**JESSE VIERTTEL MEMORIAL AIRPORT
BOONVILLE, MISSOURI**

MoDOT Project No. 17-039A-1

ADDENDUM NO. 1

June 6, 2018

LIGHTING PLAN

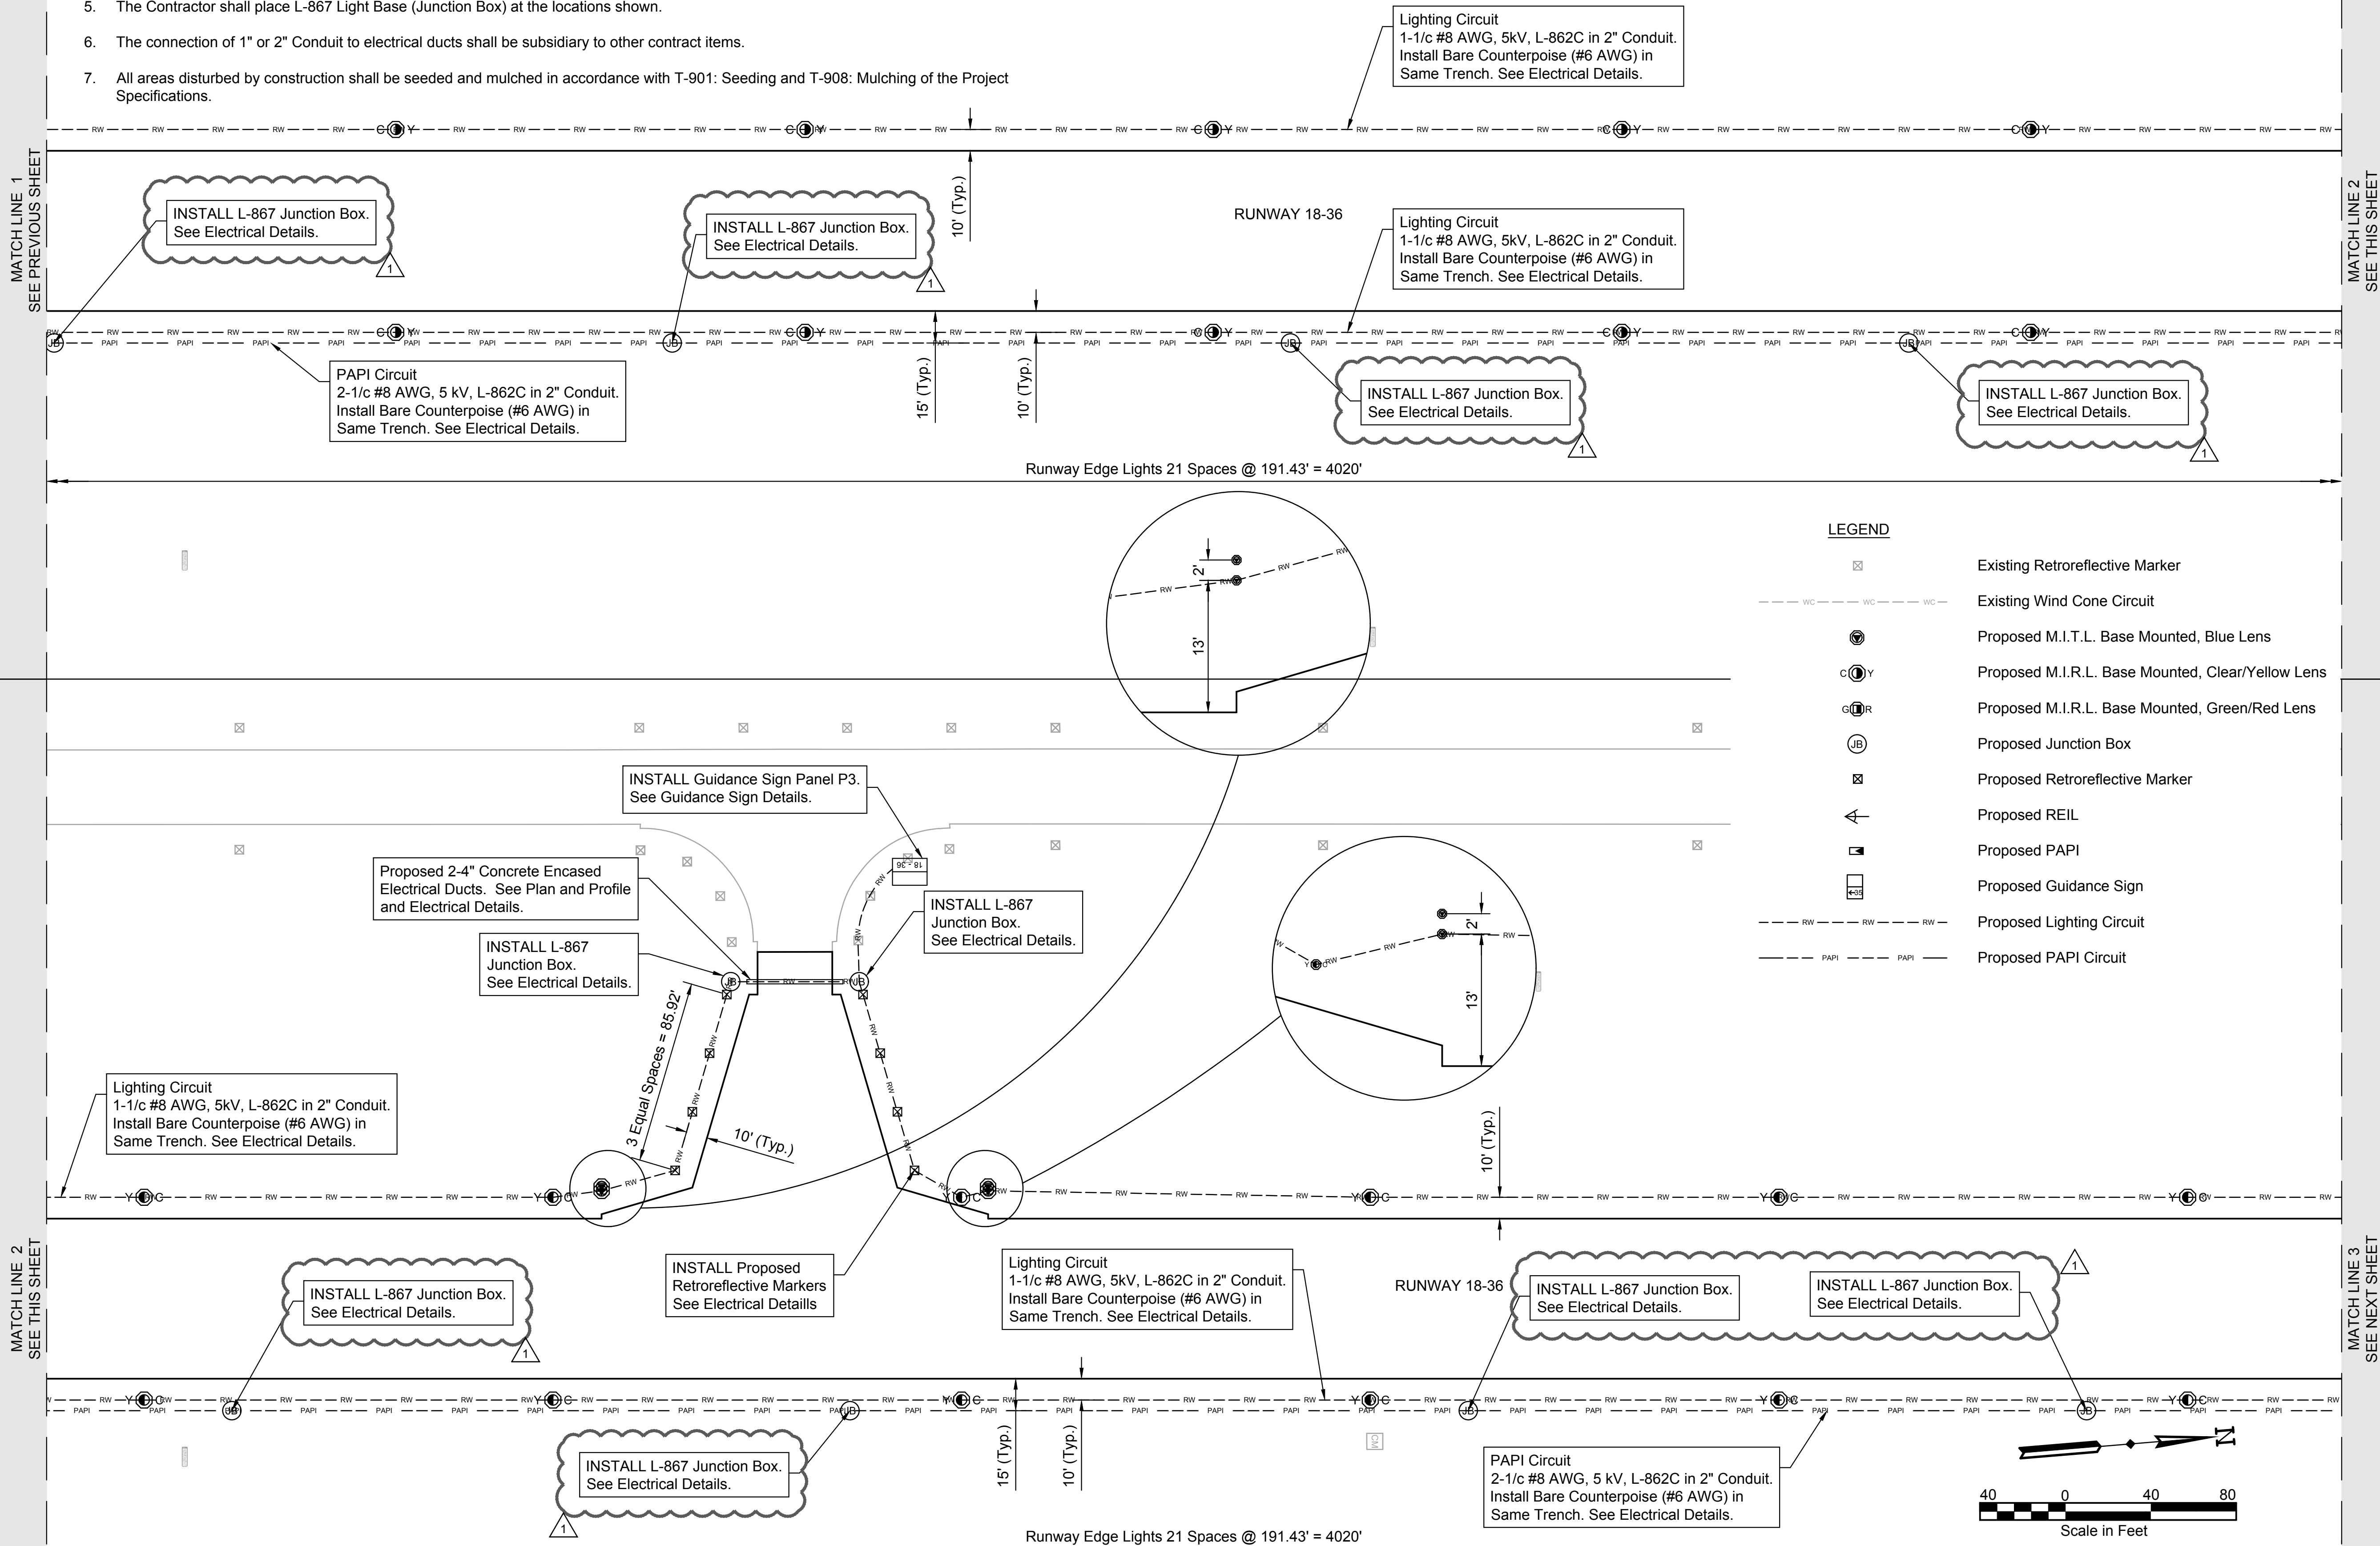
5. Sheets 35-36, Lighting Plan. These sheets have been revised to install additional L-867 Junction Boxes along the proposed Runway 18 PAPI circuit.

CABLES IN CONDUIT
TRENCHING DETAIL

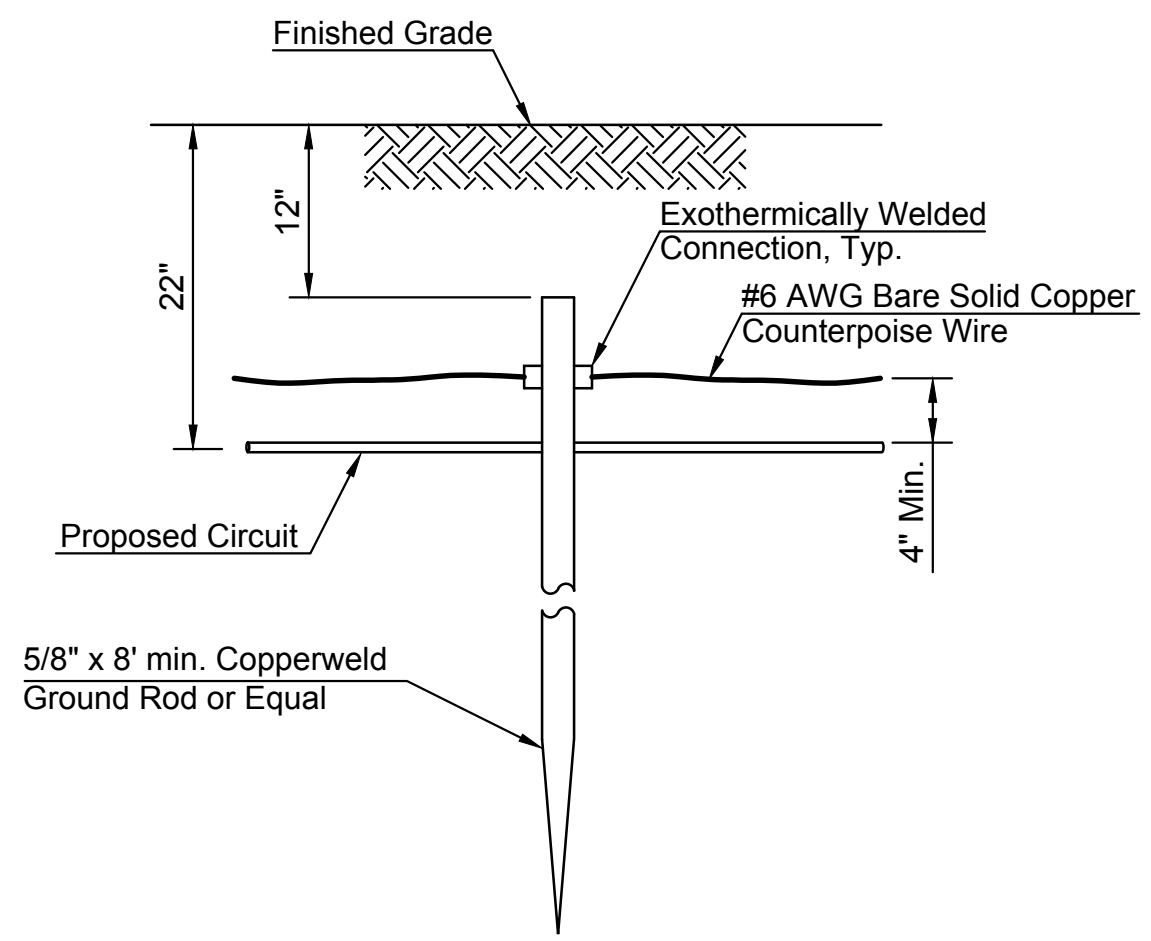
6. Sheet 38, Electrical Details. Note 3 has been added to the Cables in Conduit Trenching Detail as follows:

“3. Where the cable trench is parallel with pavement the Contractor has the option to install the Counterpoise in a separate trench located 5’ off of the pavement edge. Separate trench for the counterpoise shall not be paid for. Installation of Counterpoise shall be paid for as Contract Item “Bare Copper Counterpoise in Same Trench as Conductors”. All base cans shall be grounded by connection to the counterpoise system or individual ground rods at each base can.”

1. Depth of Trenches Shall be as Shown Above Unless Otherwise Specified on the Plans.
2. Sand Backfill May be Waived by the Engineer if the Existing Soil Meets the Backfill requirements. All Disturbed Surfaces Shall be Restored to Their Original Condition Including Returfing; Cost is Incidental to Trenching.
3. Where the cable trench is parallel with pavement the Contractor has the option to install the Counterpoise in a separate trench located 5' off of the pavement edge. Separate trench for the counterpoise shall not be paid for. Installation of Counterpoise shall be paid for as Contract Item "Bare Copper Counterpoise in Same Trench as Conductors". All base cans shall be grounded by connection to the counterpoise system or individual ground rods at each base can.

VAULT BUILDING MODIFICATIONS

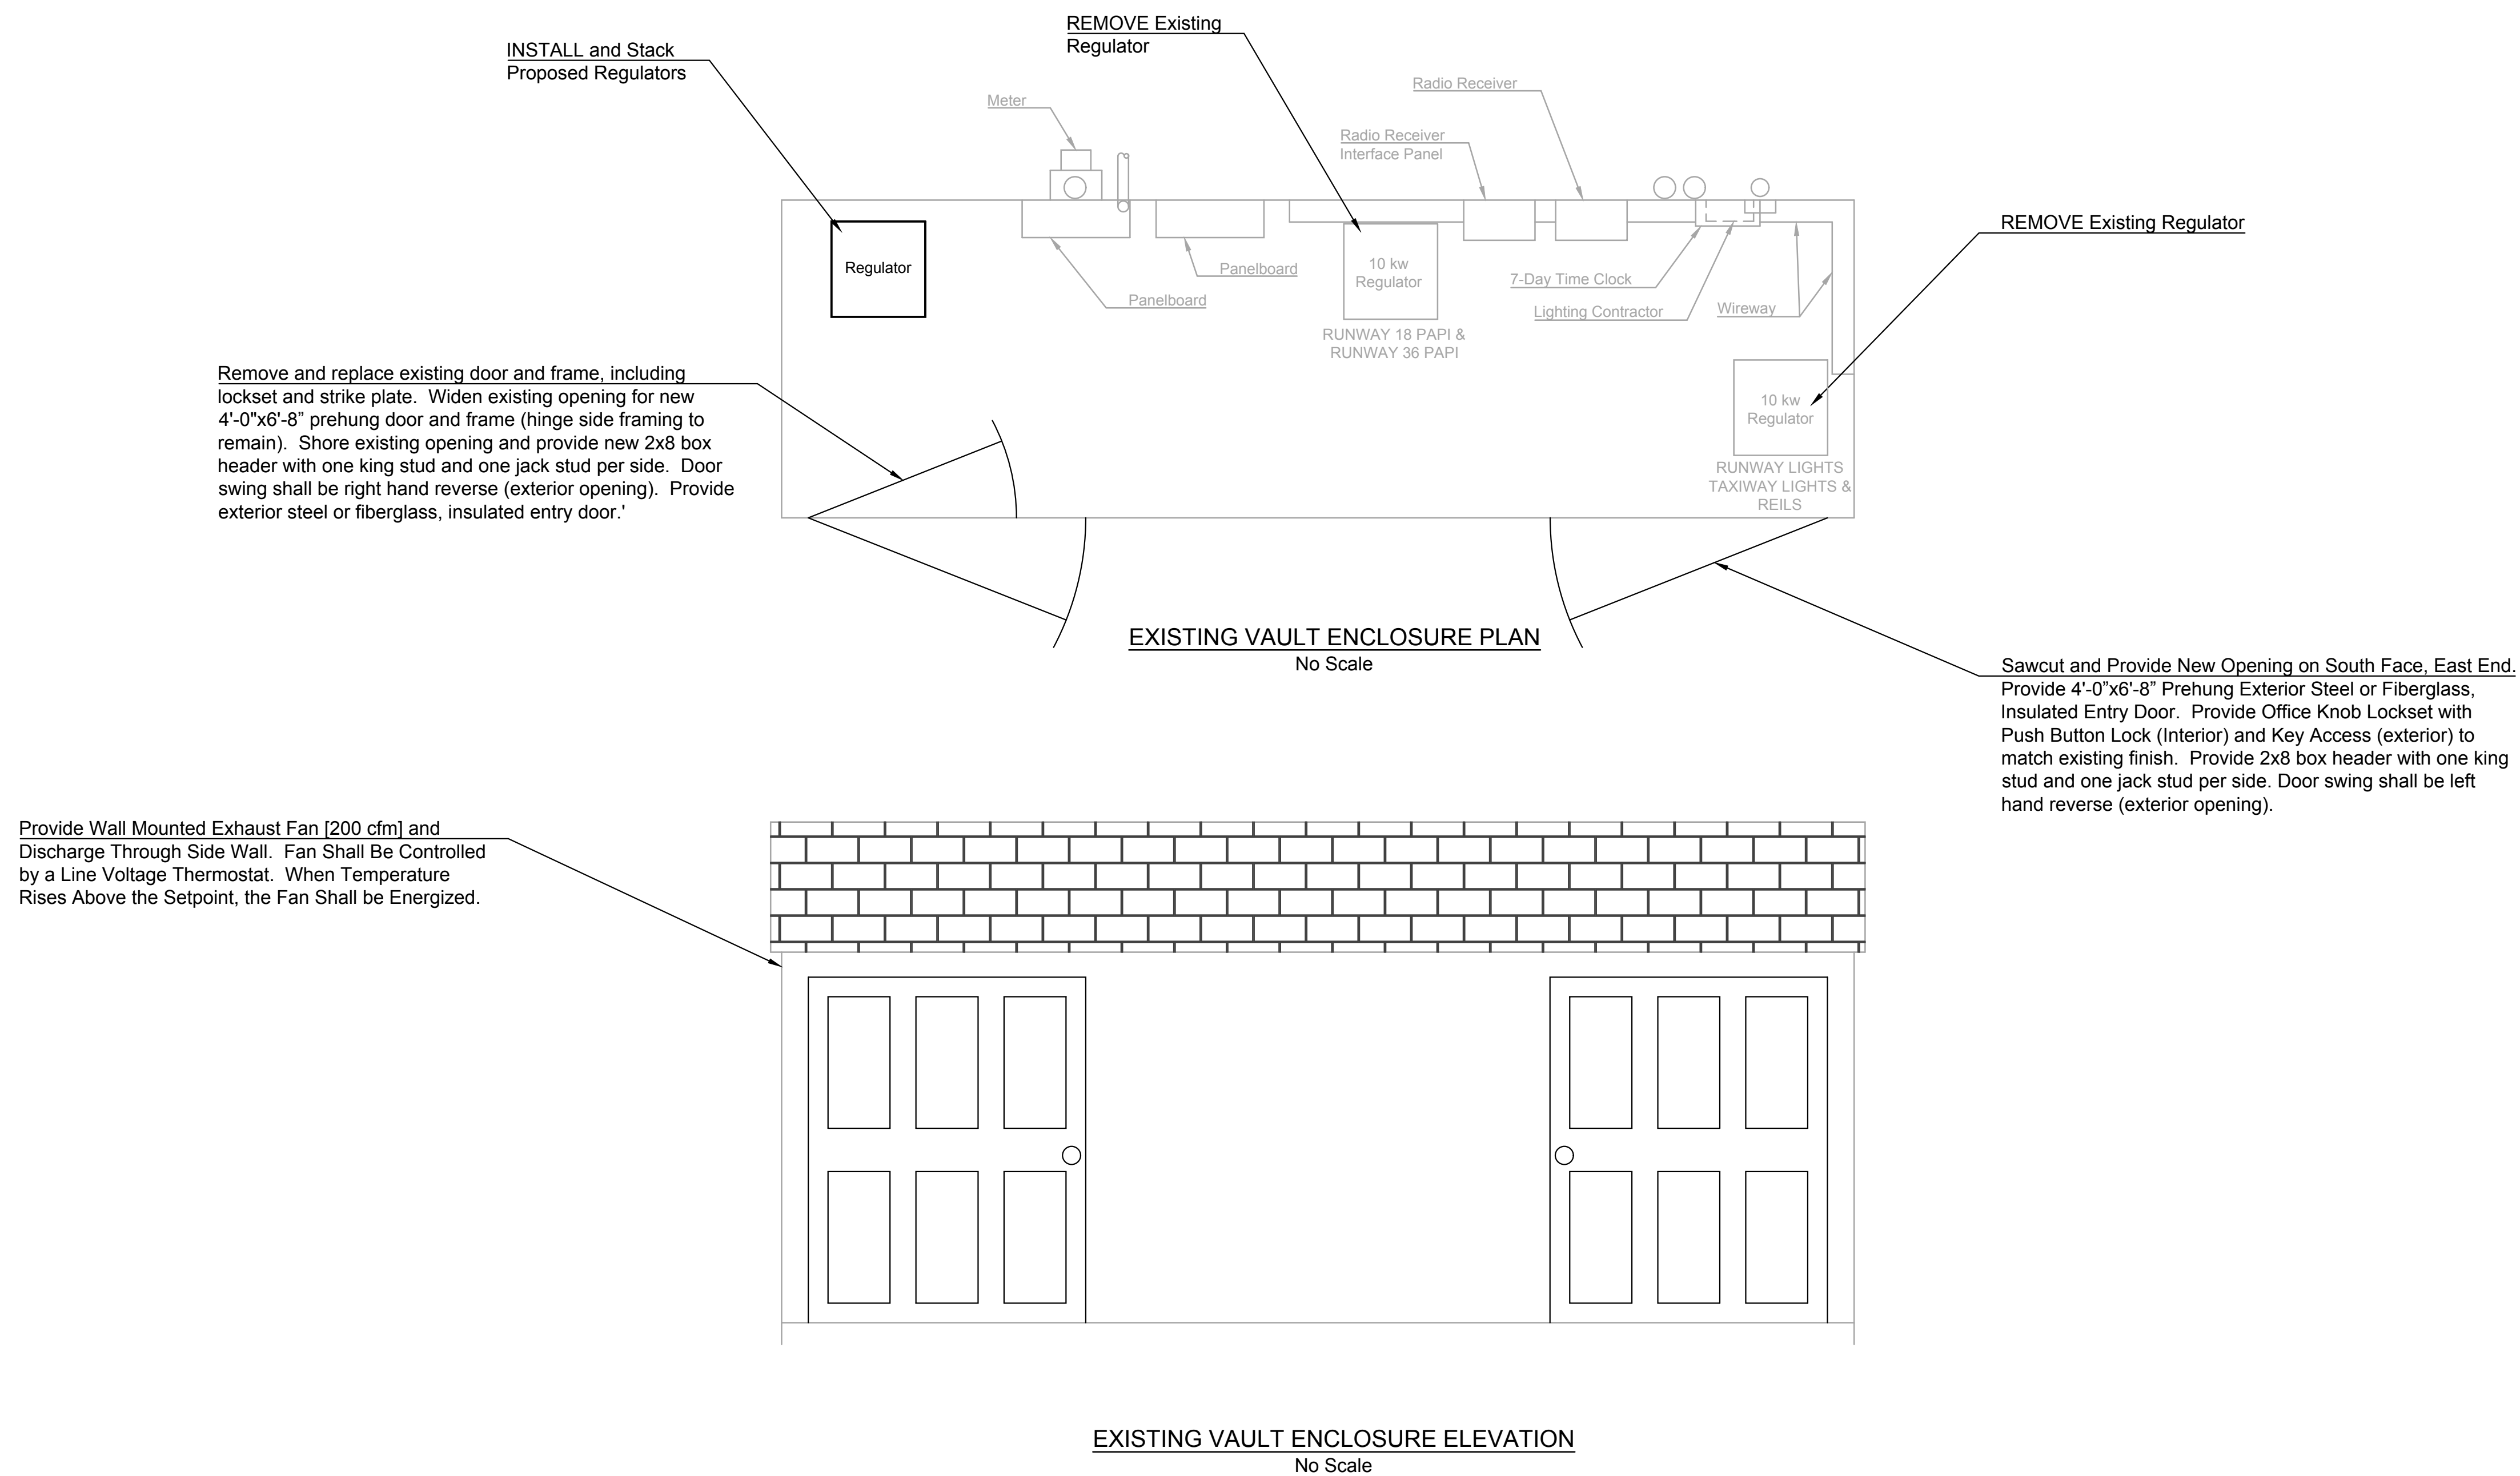
7. Sheet 43A, Vault Building Modifications. This sheet has been added to depict the necessary modifications to the vault building itself, which include the removal of the existing pedestrian door, installation of two new pedestrian doors, and installation of an exhaust fan (in addition to the electrical modification already depicted on Sheet 43. All modifications related to the vault building or vault building equipment shall be paid for with the lump sum Contract Item “Vault Modifications, Complete”.
